**Mont-Joli Airport, Quebec
Former Building H-3, Former Coal Depot and Former Landfill**

Remediation Plan

**Responses to the Supplemental Information Request from MDDEP
dated July 20, 2011,
Concerning Remediation of the Former Hangar H-3 Sector**

Dessin / Drawing:
FIGURE 3.1
Synthèse des données
Secteur de l'ancien bâtiment H-3

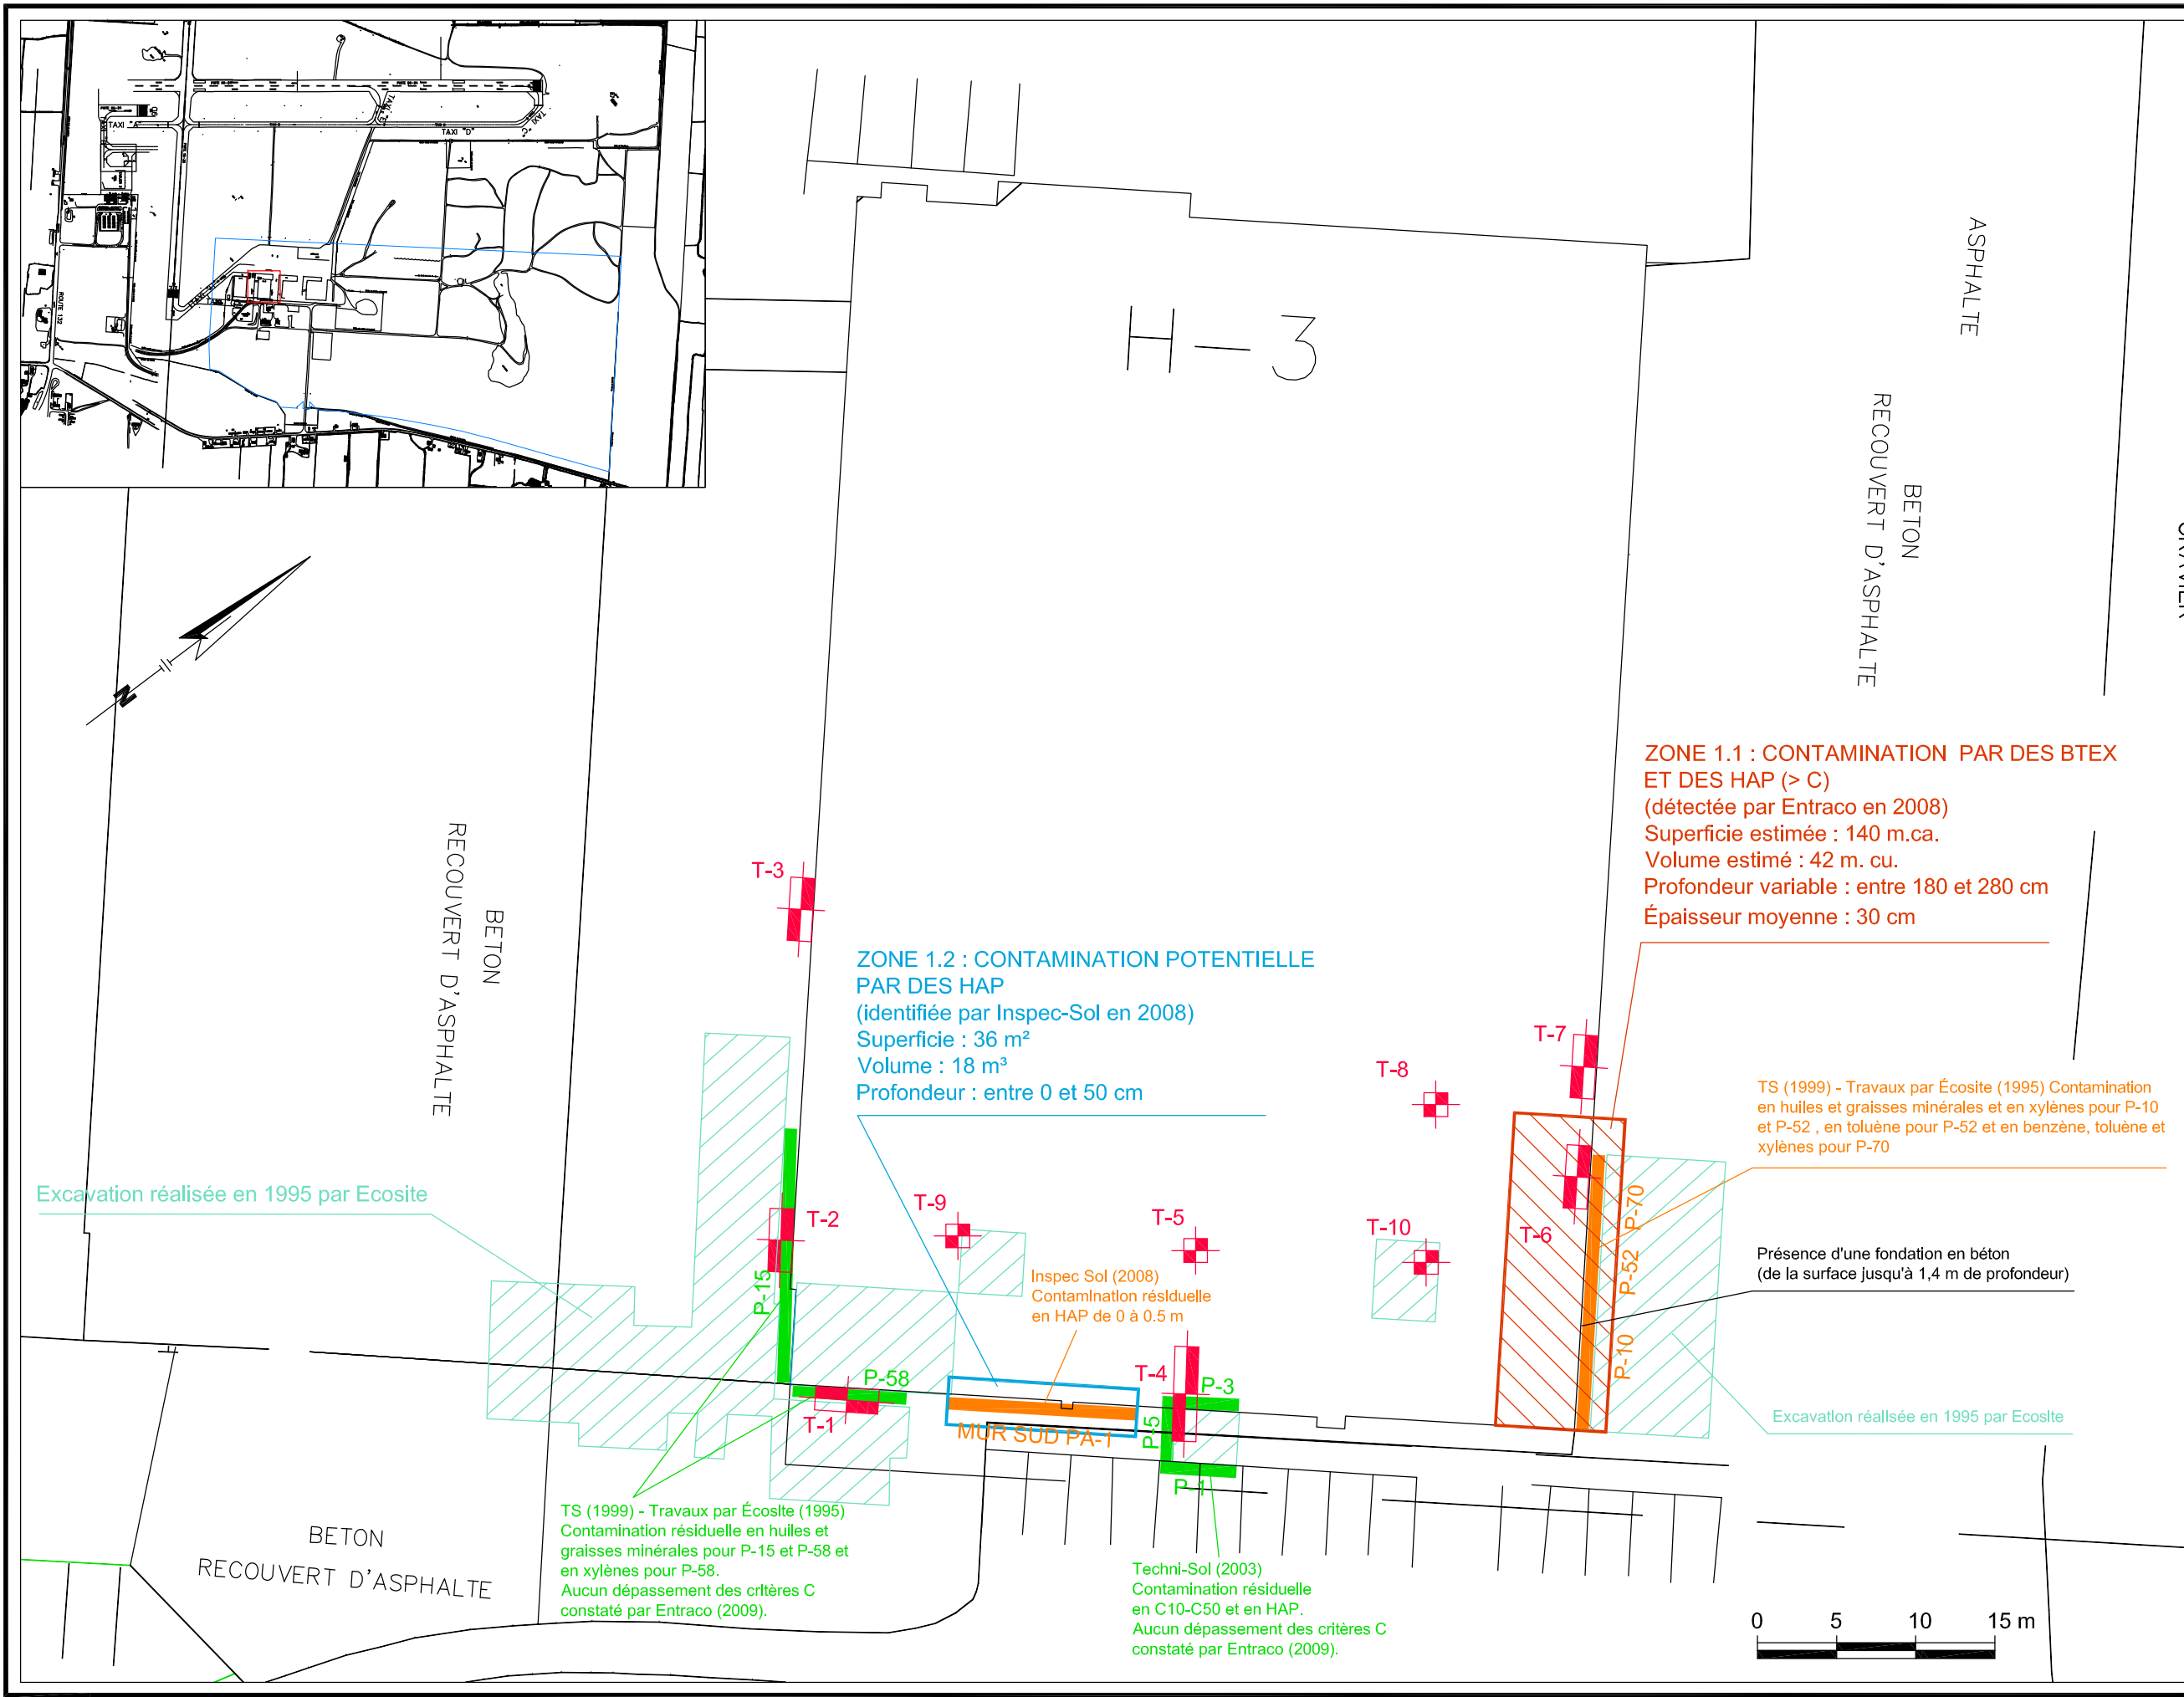
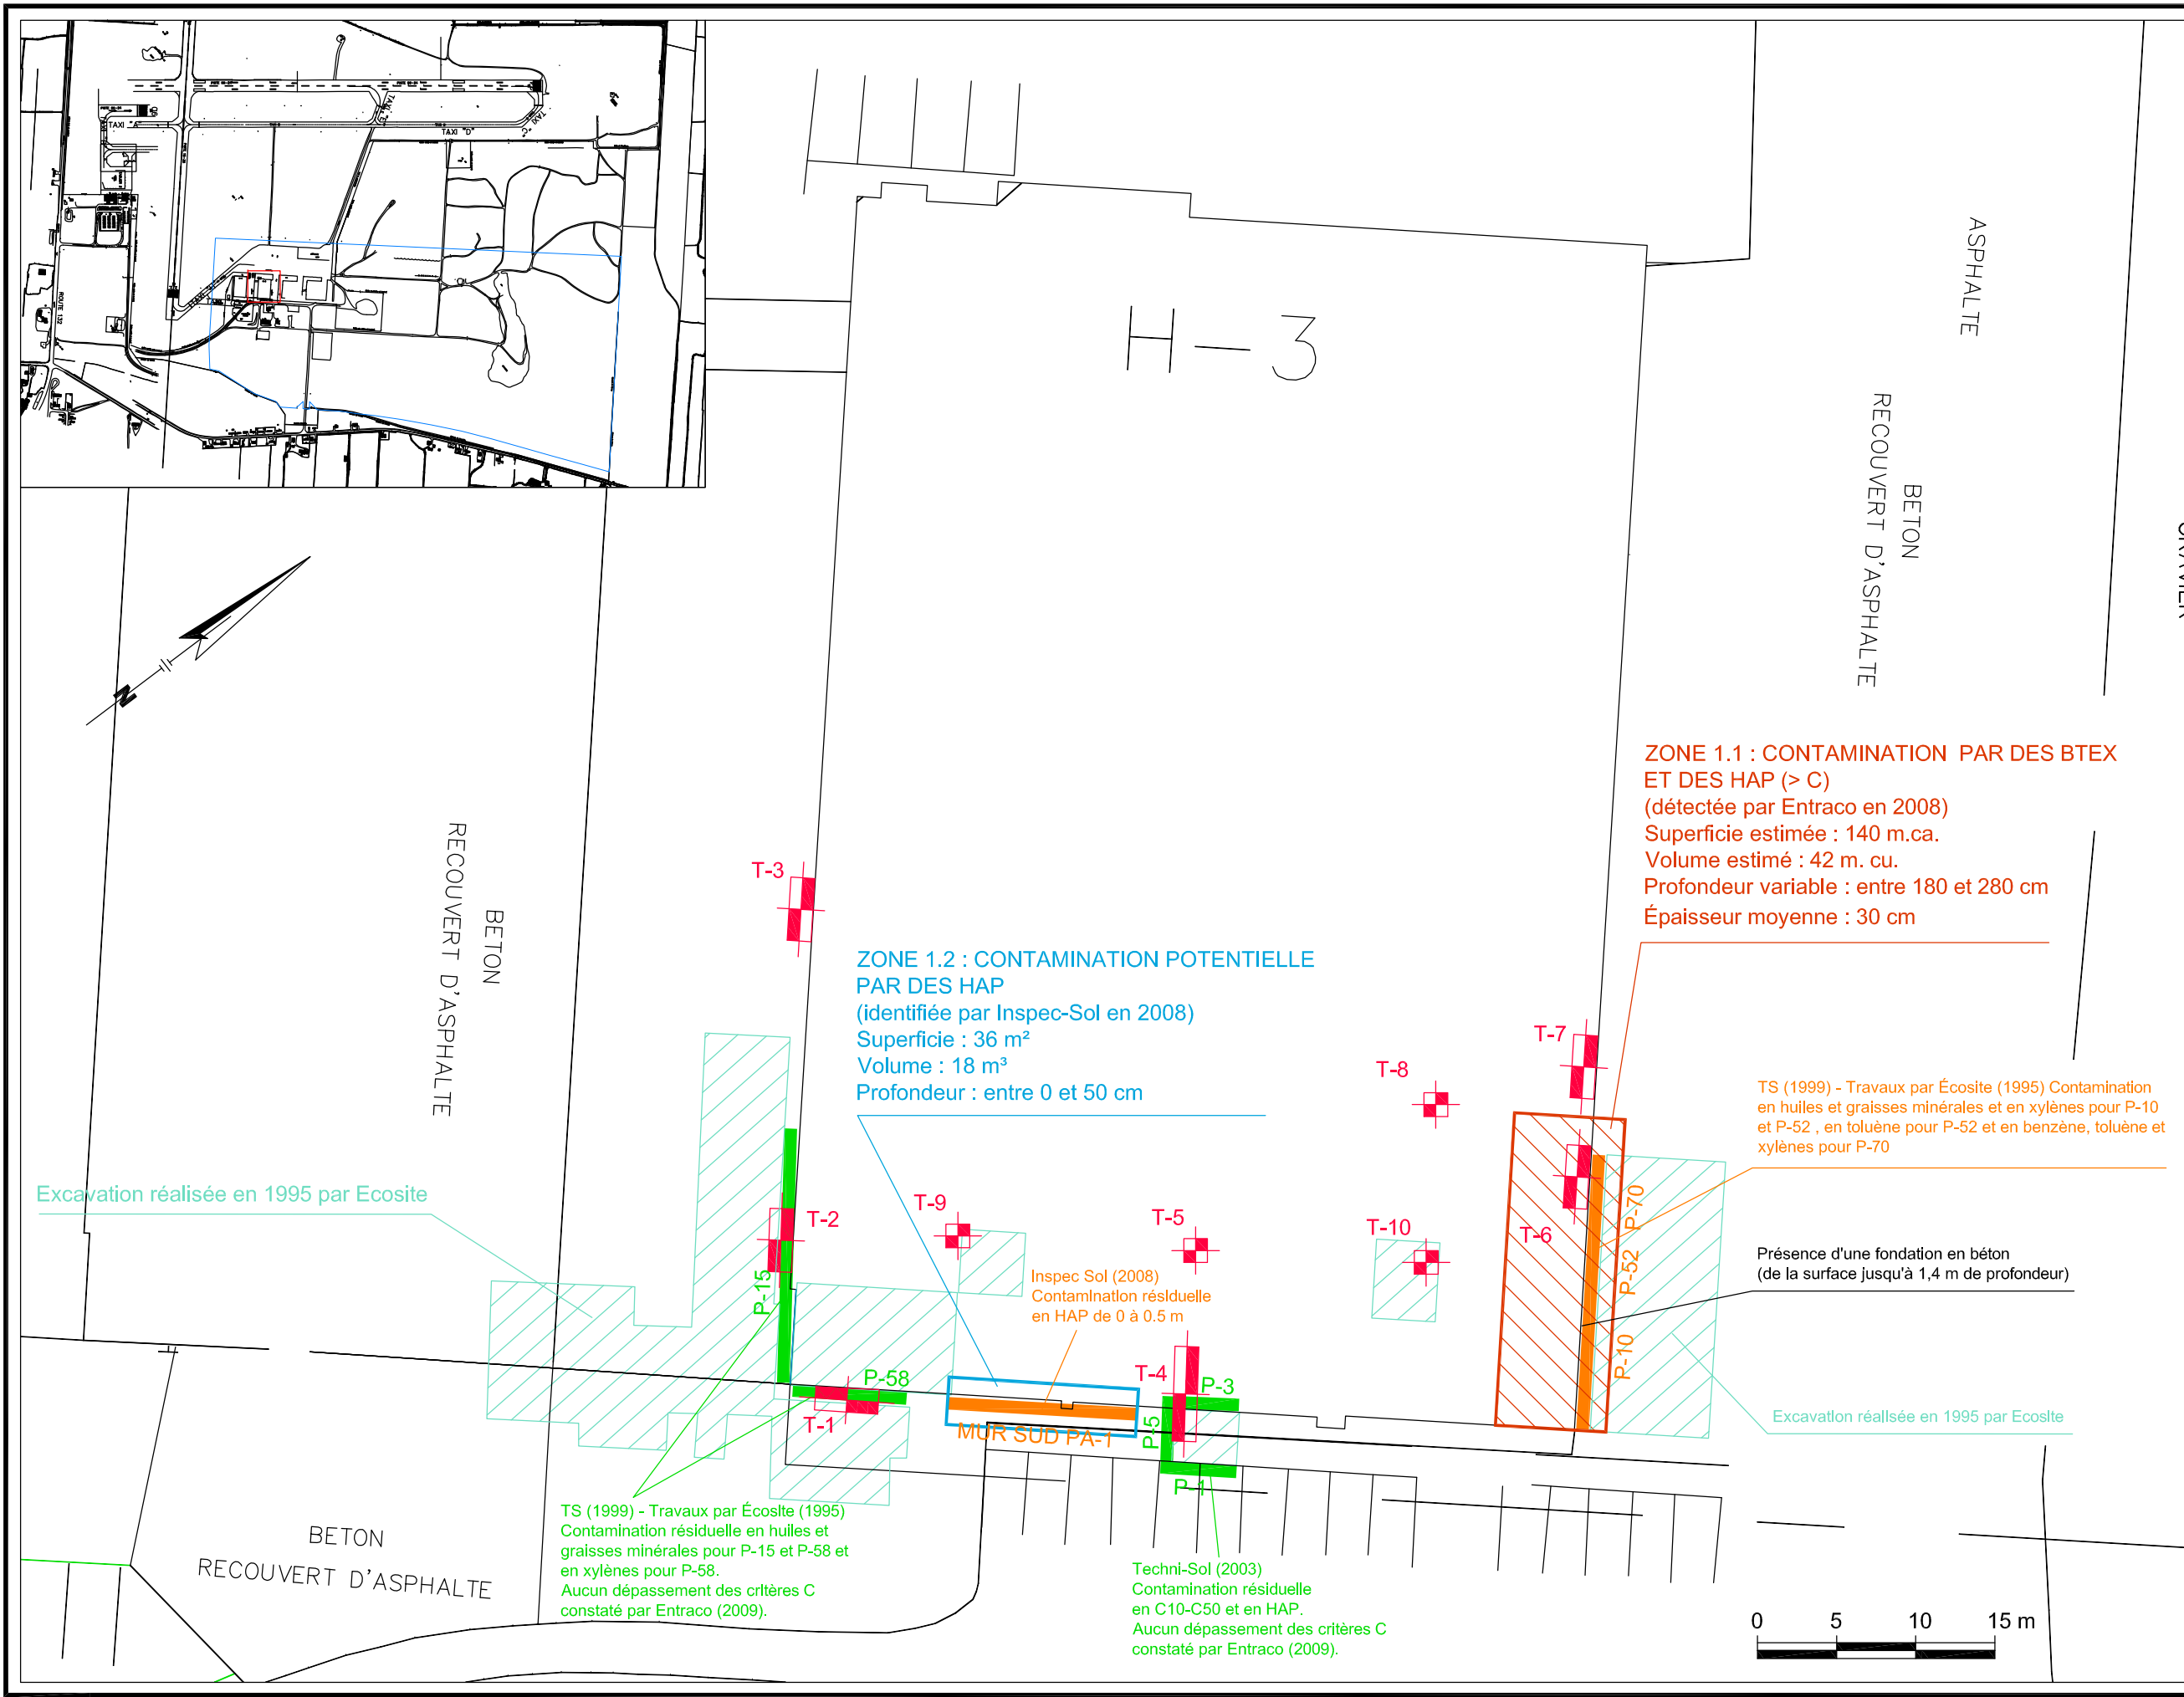
5. For the two areas of residual contamination shown in Figure 3.1 in the Plan, the following information has been added (see Annex 2): "No exceedance of level C observed by Entraco (2009)." According to the Entraco study (2009), the TPH C₁₀-C₅₀ concentrations are in the B–C range in trenches T-2 and T-4, and in the A–B range in trench T-1. In 2008, during demolition of hangar H-3, no exceedances of level C were observed by Inspec-Sol in this sector.
6. The quantity of potentially contaminated soil along the southern wall of former hangar H-3 was estimated at 18 m³ within an area of 36 m². These figures, which have been used in the remediation plan, are based on the results of the Entraco study (2009).

The values used by LVM were taken from the Inspec-Sol study (2008) and are based on the results of a single sample from an excavation along the wall, where the northeastern limit was not determined. LVM will use the same values as those estimated by Entraco.
